Number: 77-5

Date : 3/1/77

- A. Replacement Hinge Pin and Retaining Pin for MerCruiser I Drives
- B. MerCruiser Engines Pre-Filled with Engine Oil
- C. Water Pickup Inserts on MerCruiser I Drive Models
- D. MerCruiser 470 Cooling System
- E. "Micro-Card Change Notices" File Cards

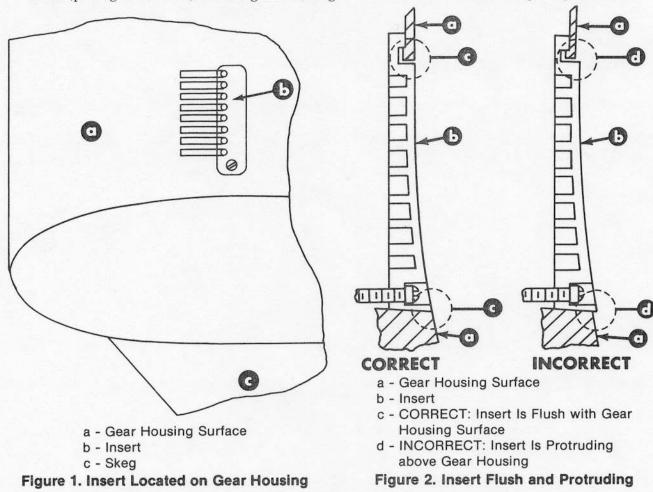
Starting November 1, 1976, MerCruiser Engines were shipped with oil in the crankcase. A red warning tag (C-90-77795) is attached to the oil filler cap on these units to designate that the crankcase has been filled. After boat installation, the engine oil level MUST BE rechecked to be sure that engine oil is at the proper level.
